DESIGN REVIEW BOARD

**June 9, 2026
7:00 PM**

**Town of Bay Harbor Islands, FLORIDA
Design Review Board
ADVISORY BOARD AGENDA ITEM REPORT**

AGENDA ITEM NO. 1

SCALE 1/8" = 1'-0"

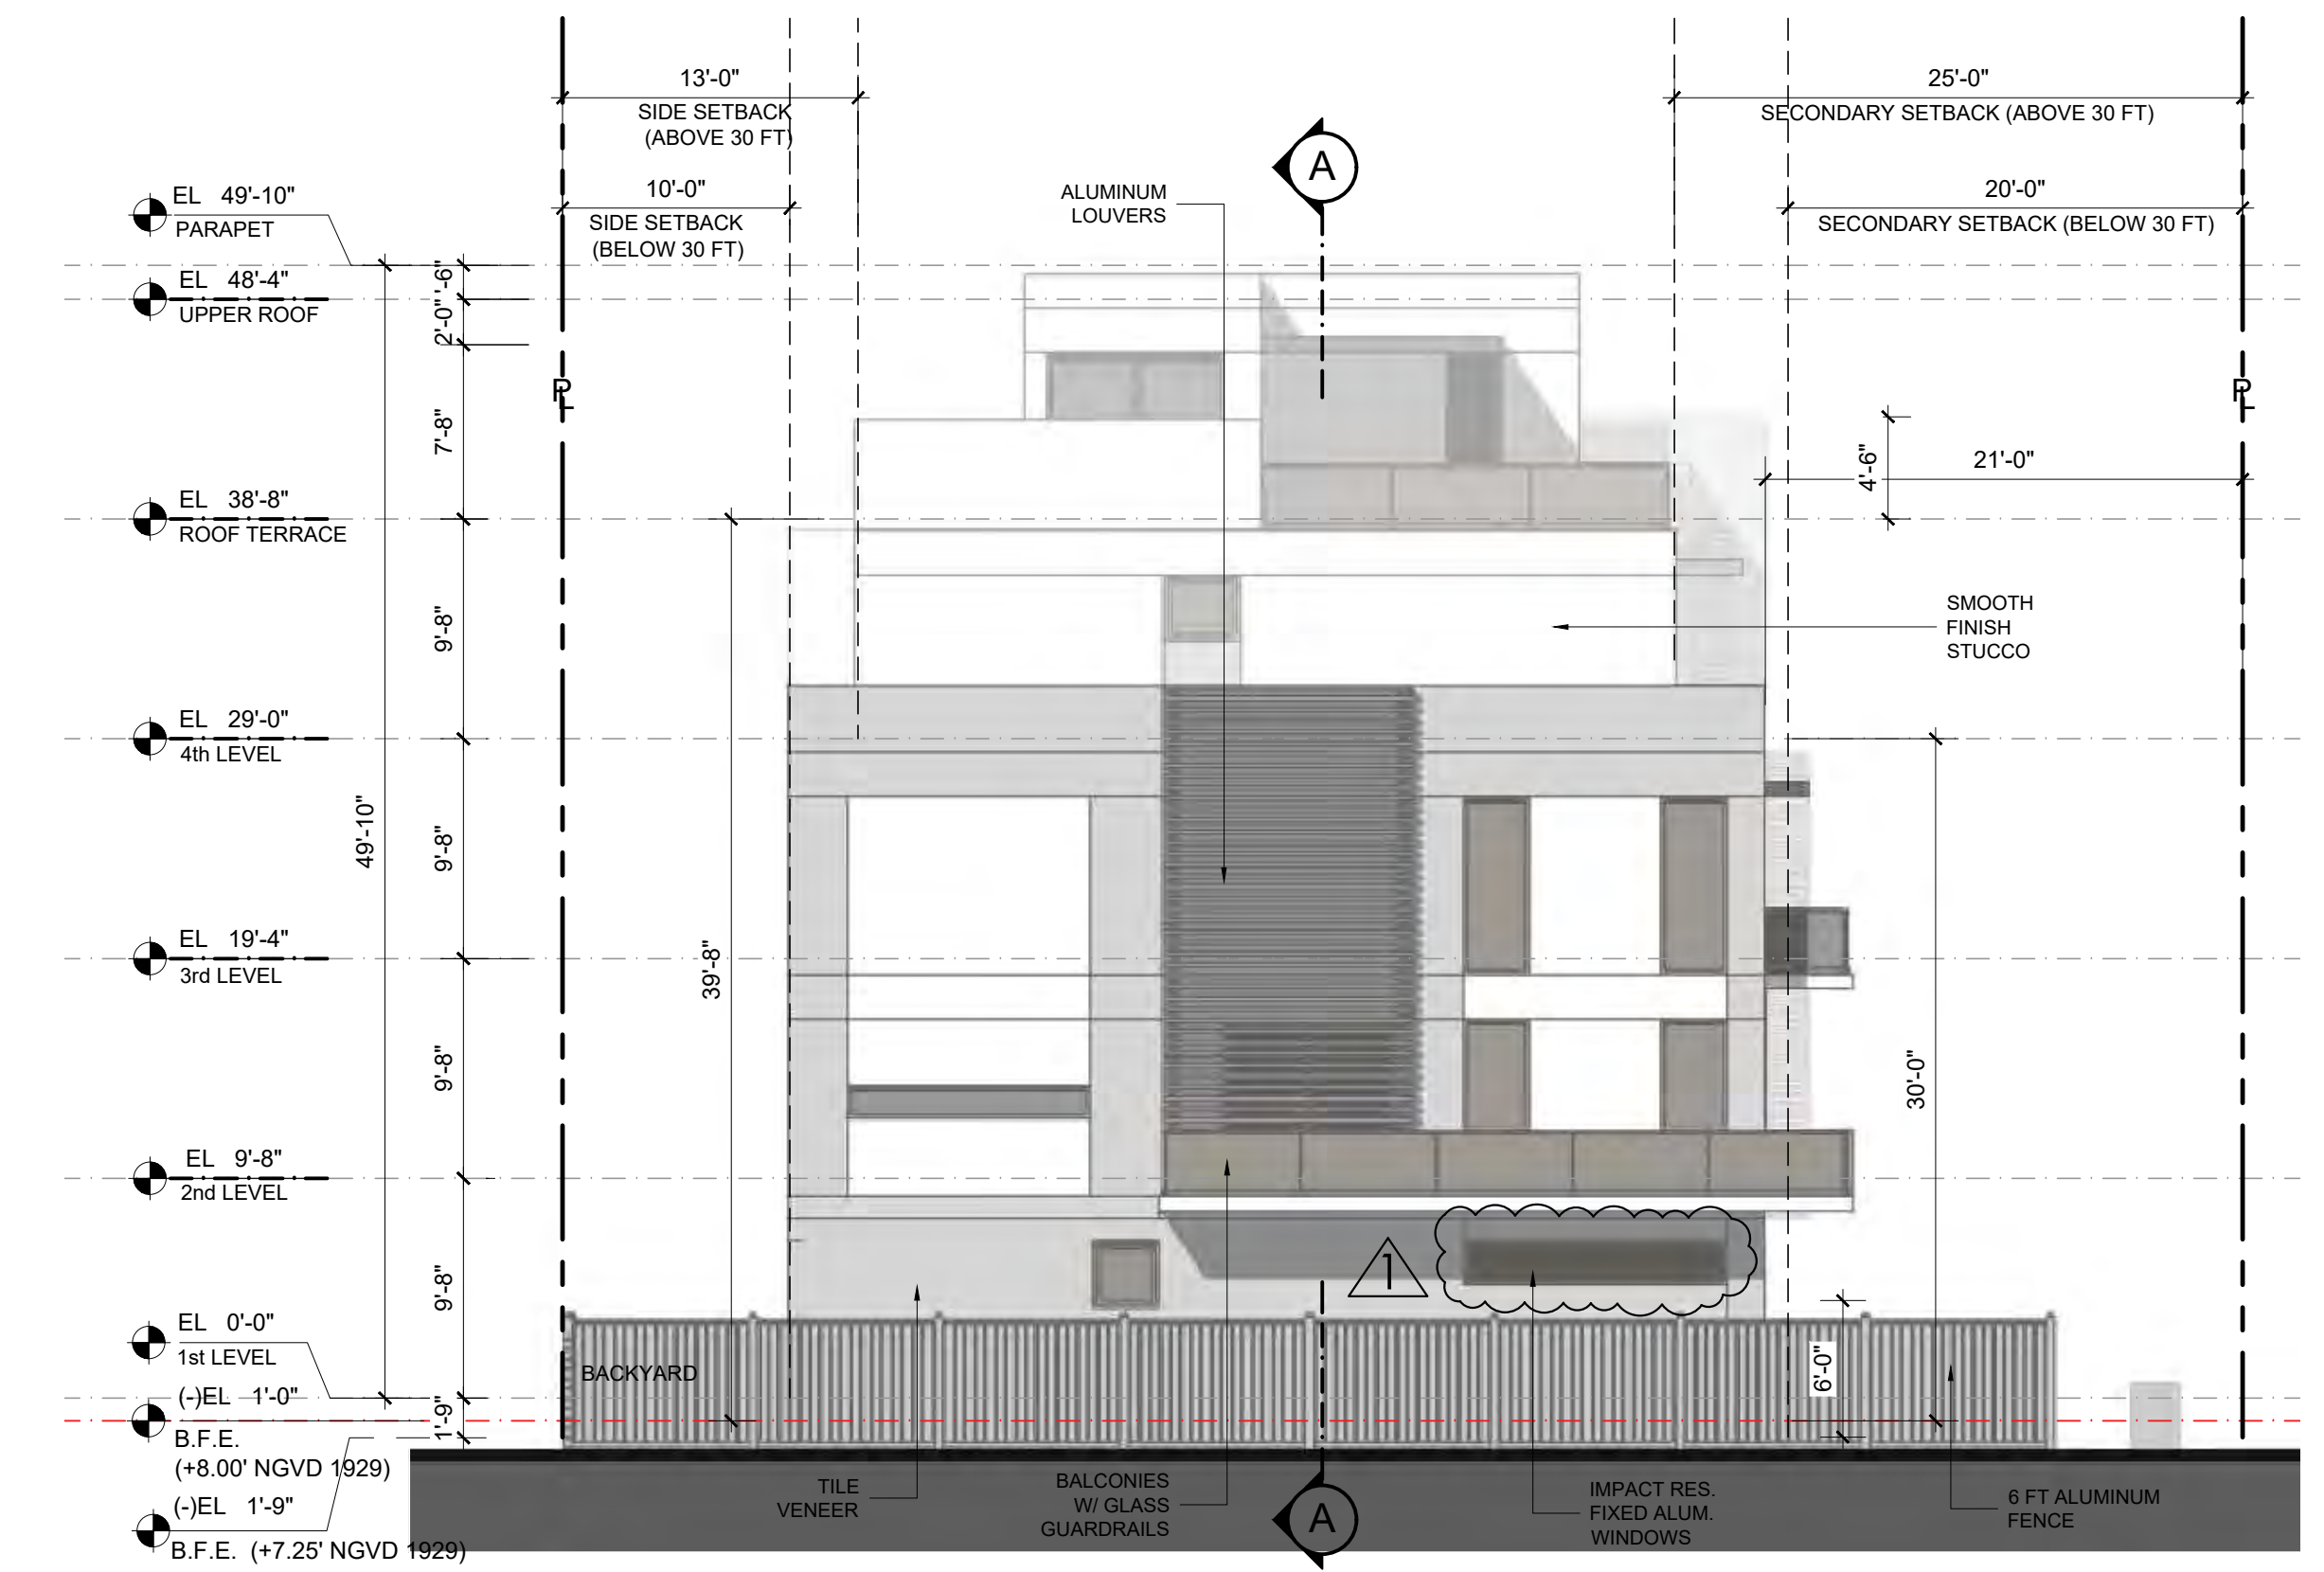
This item is brought back to the DRB for re-review due to exterior changes made by the applicant during the building permit review process that do not match the DRB-approved plans. Specifically, Sheet A-3.1 does not match the approved design, with doors and windows changed, window sizes altered, and a four (4) foot wide window removed on the first floor. The applicant did not request prior DRB approval for these changes. Staff identified the changes and consulted the DRB Chair, who confirmed that the project must return for review.

The applicant submitted permit plans that deviate from the DRB-approved design. While minor adjustments are typical during permit review, the following changes constitute a material change to the exterior appearance requiring DRB re-approval:

1. Doors: Doors have been changed from the approved design.
2. Windows: Window sizes have been changed from the approved design.
3. Windows: A four (4) foot wide window on the first floor has been removed.
4. Sheet A-3.1: This sheet does not match the DRB-approved design.

Recommended Action: Staff recommends that the Design Review Board review the proposed changes and, if found acceptable as submitted or with modifications, approve the Site Development Plan subject to the staff recommended conditions listed herein, or any additional changes or conditions felt to be necessary by the DRB.

LANDSCAPE PLAN

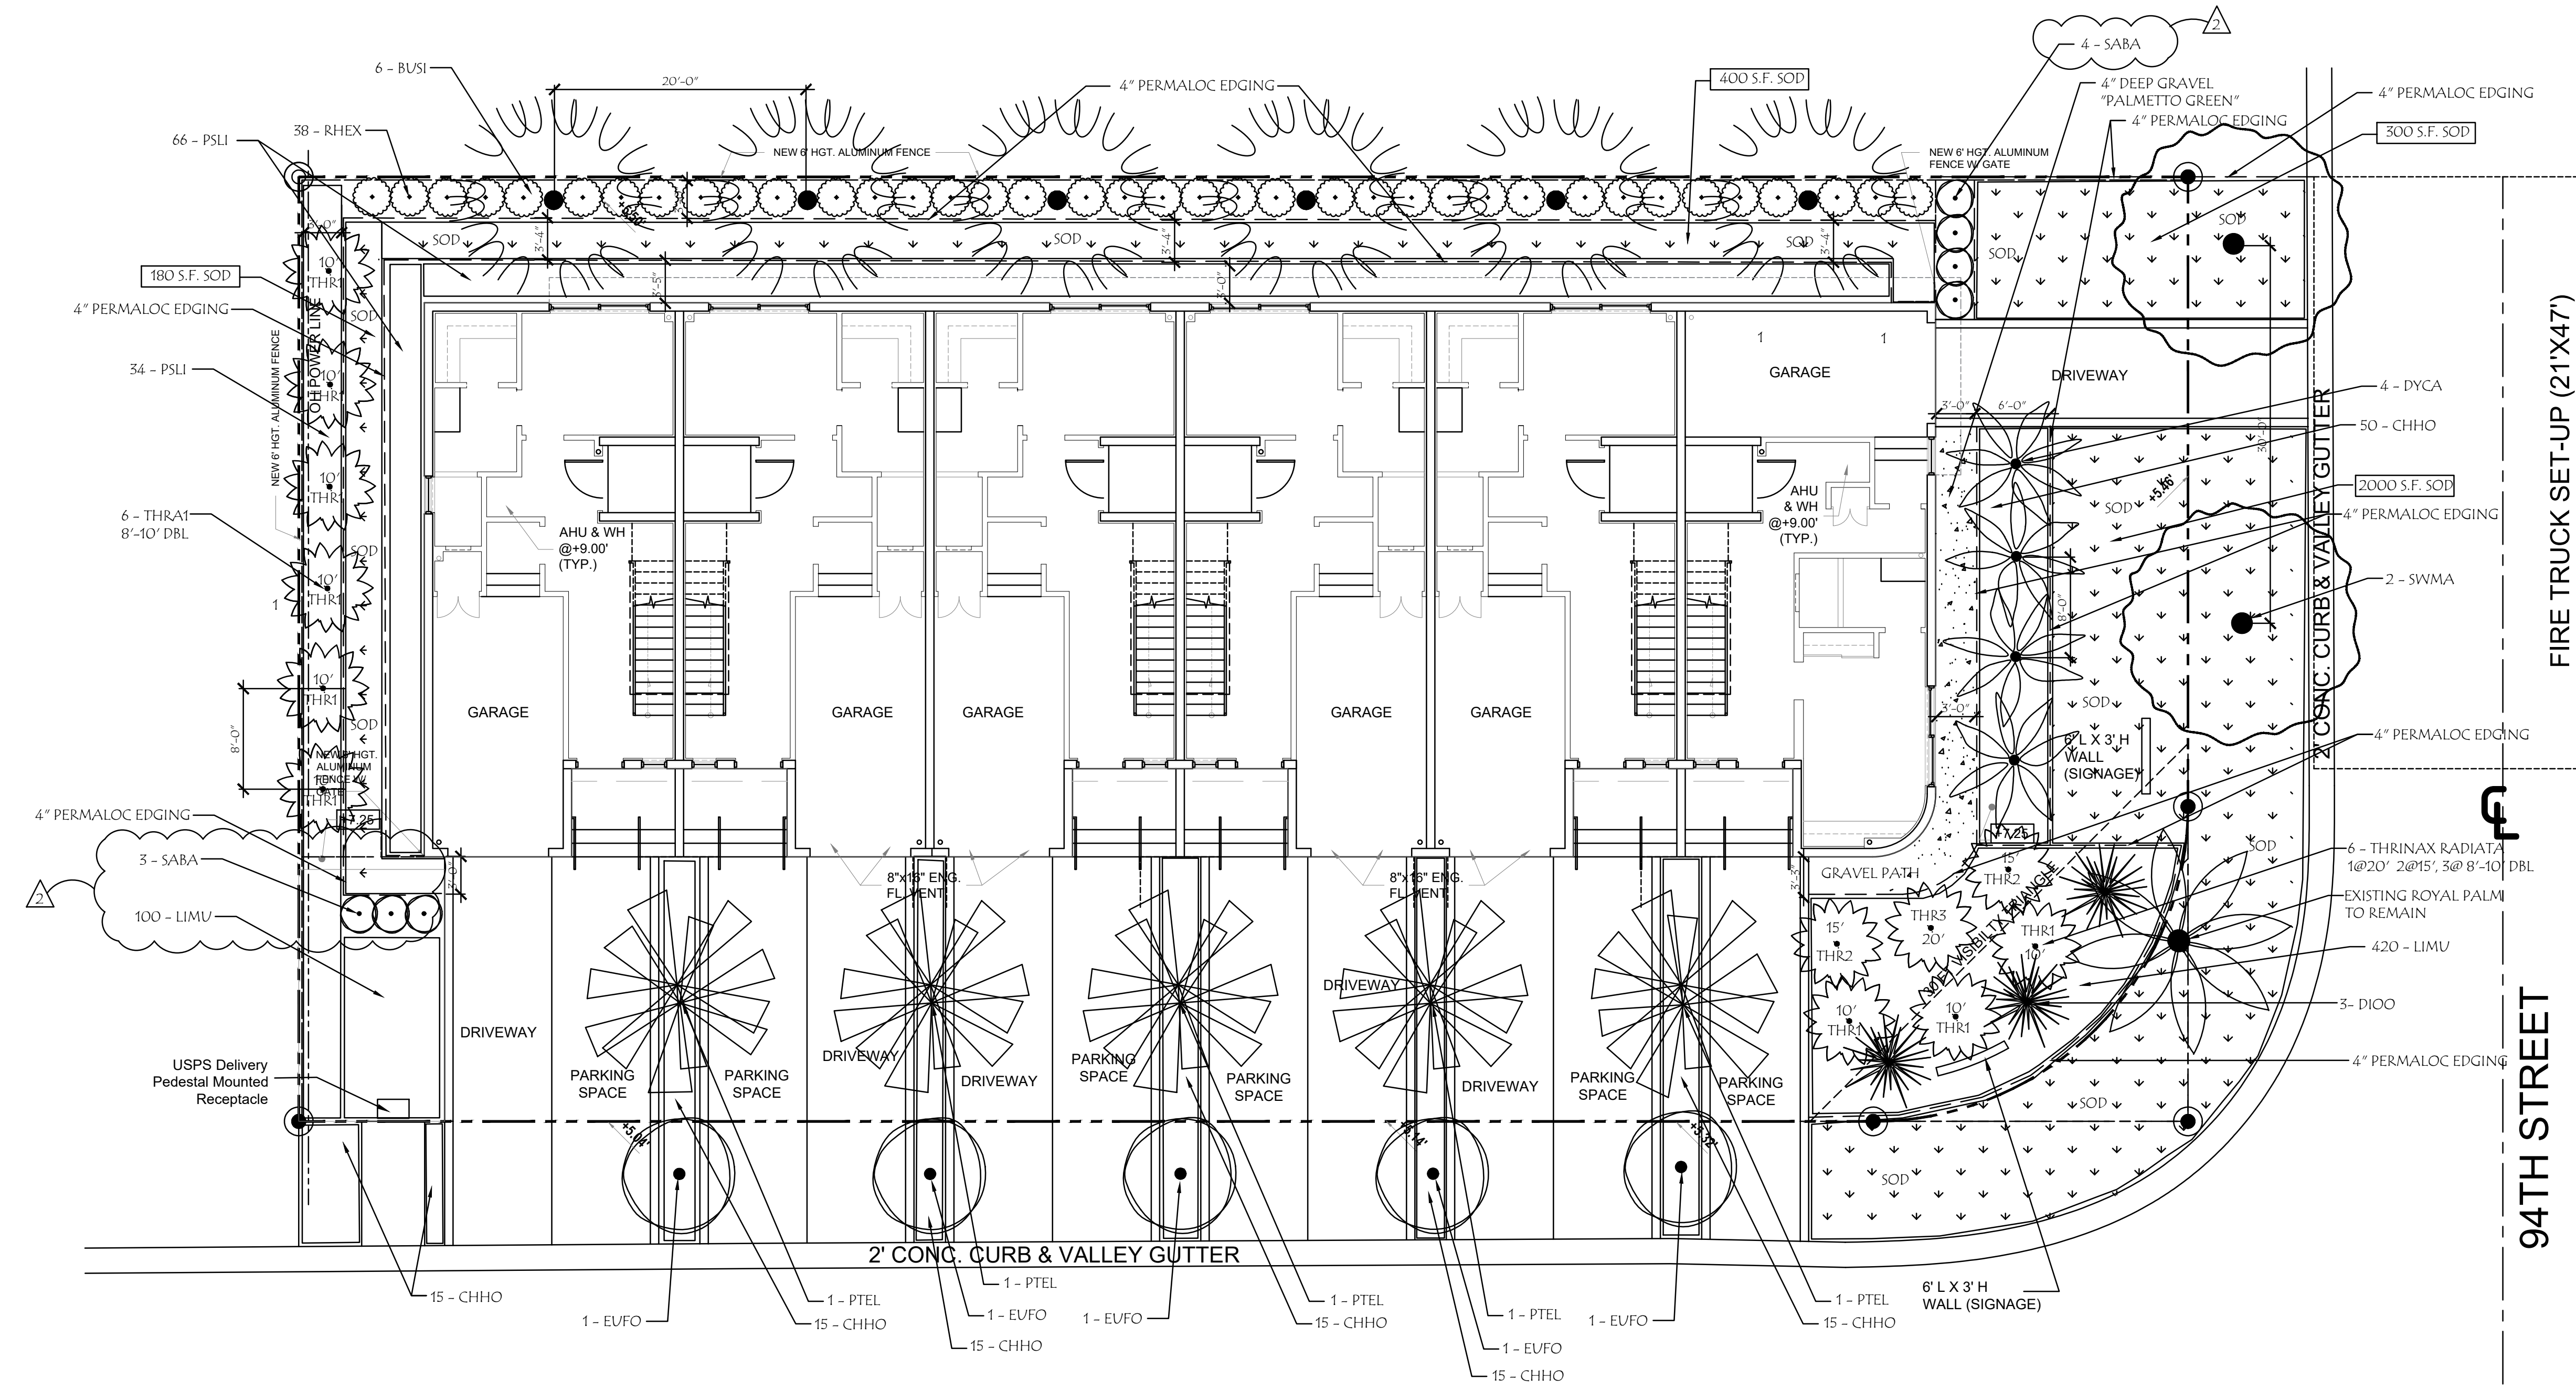
2. **Street Tree Requirements:** The proposed Spanish Stopper tree does not meet the minimum height requirements for street trees. Pursuant to Code requirements, all street trees shall have a minimum overall height of fifteen (15) feet, with at least six (6) feet of clear trunk before branching, and a minimum caliper of two and one-half (2½) inches at the time of planting. Street trees shall also comply with the Miami-Dade County minimum spacing criteria of thirty-five (35) feet average separation and shall not exceed forty (40) feet on center. Please revise accordingly to meet the Town's landscaping and street tree requirements.
